# Access Compliance Report

## Public Rights-of-Way

Intersection ID: 48587	Main Street: STONEY_CREEK_LN	Cross Street: UNIVERSITY_CITY_BV	Location: NE
ADA ID: 072D1AC50C6F	Ramp Type: BlendTrans1	Initial Pass/Fail: Fail	Overall Compliance: No
Severity Score: 8.75			
Codes/Mitigation Info/Possible Solution		Field Measurements/Component Compliance

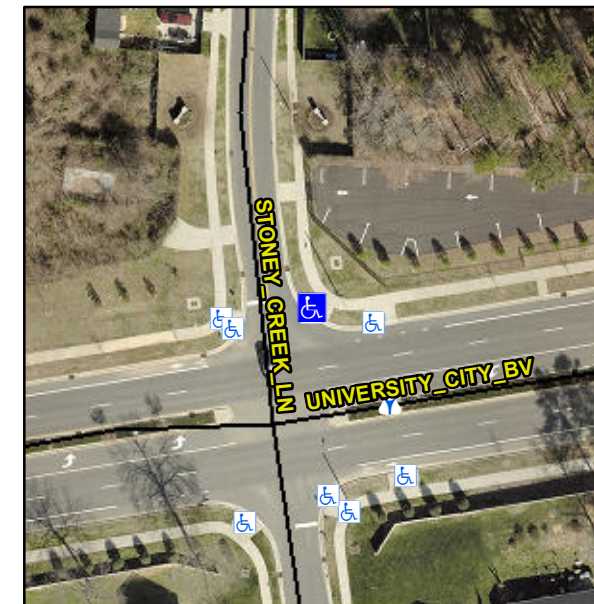
**Not Found, R304.5.1**

Compliance	Description	Data	Compliance	Description	Data
N/A	Ramp Length (in)	96.5	Yes	BlendTrans Slope (%)	3.5
No	Ramp Width (in)	47.5	Yes	BlendTrans XSlope (%)	0.7
N/A	Flare Type LT	N/A	N/A	Flare Type RT	N/A
N/A	Flare Slope LT (%)	N/A	N/A	Flare Slope RT (%)	N/A
N/A	Flare Traversable LT?	N/A	N/A	Flare Traversable RT?	N/A
N/A	Landing Length (in)	N/A	N/A	DWS Provided?	N/A
N/A	Landing Width (in)	N/A	N/A	DWS Contrast?	N/A
N/A	Landing Slope (%)	N/A	N/A	DWS Length (in)	N/A
N/A	Landing X Slope (%)	N/A	N/A	DWS Full Width?	N/A
N/A	Landing Curb? (Y/N)	N/A	N/A	DWS Offset (in)	N/A
N/A	Shared Landing?	N/A			
N/A	Gutter Ponding?	N/A	N/A	Gutter Slope (%)	N/A
N/A	Gutter Lip Ht (in)	N/A	N/A	Gutter X Slope (%)	N/A
N/A	Painted X Walk1?	No	N/A	Painted X Walk2?	No
	X Walk 1 Direction	To NW		X Walk 2 Direction	To SE
	X Walk 1 Width (in)	N/A		X Walk 2 Width (in)	N/A
	X Walk 1 Slope (%)	1.5		X Walk 2 Slope (%)	1.4
	X Walk 1 X Slope (%)	2.1		X Walk 2 X Slope (%)	1.3

N/A	Ramp inside XWalk1?	N/A	N/A	Ramp inside XWalk2?	N/A
	Road Slope (%)	1.2		Clear Space?	N/A
	Road X Slope (%)	0.8	N/A	Clear Space to XWalk (in)	N/A
N/A	Any Obstructions?	N/A	N/A	Storm Grate/Utility Hazard?	N/A
	Obstruction Type			Storm Grate/Utility Type	
		N/A			N/A
			Yes	Surface Condition? (G/P)	Good
			No	Curb Slope (%)	27.1

**Remove & Replace Curb Ramp With Two New Directional Ramps or Equivalent.**
